# PERMIT

**SEWAGE DISPOSAL SYSTEM**  
HOWARD COUNTY HEALTH DEPARTMENT  
BUREAU OF ENVIRONMENTAL HEALTH  
410-313-2640

UBDIVISION Dillon Property LOT NUMBER 6/7 ADDRESS 13199 Highland Road

BOUNDARY SURVEY & FOUNDATION LOCATION DRAWING  
T. J. ON BEACON

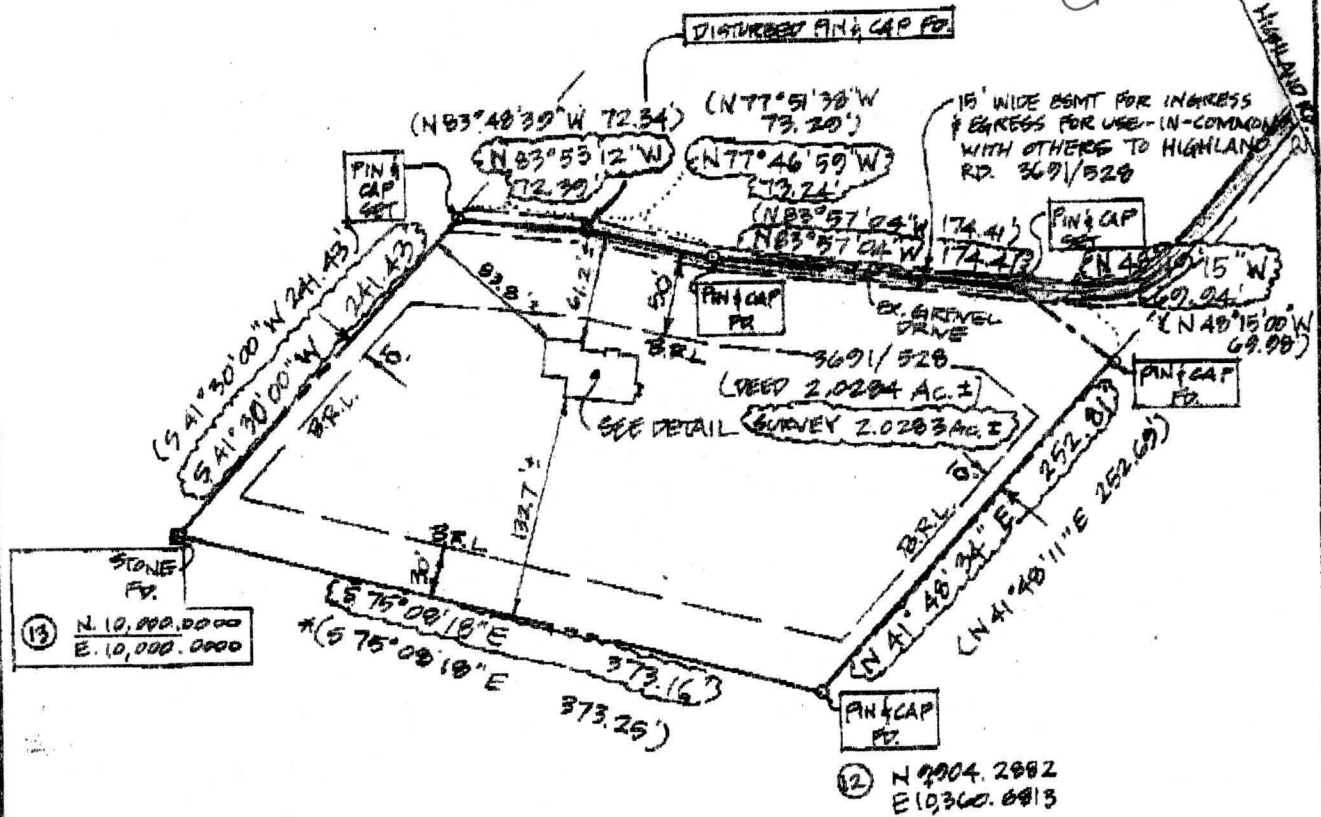
INSPECTION COMMENTS: Septic Tanks + PC set (Rock (large, platy sandstone) from 1' below grade to Bottom (Solid Rock bottom 2 1/2 ft) House Connection OK (Need Baffle & Manhole risers yet). Sand Mound Site was checked placed OK, reddish concrete Sand delivered (looks OK per uniformity & size particle size). OK to continue PIP 5/11/01

Alarm OK, But No water rise @ Turbidity and pipes when pumping - Needs a high pump to get @ least 2 ft Head pressure there. PIP 7/10/01

7/10/01 - WATER FLOWING OUT OF LATERAL END TURN UPS - (SRW) i.e. plugged OK
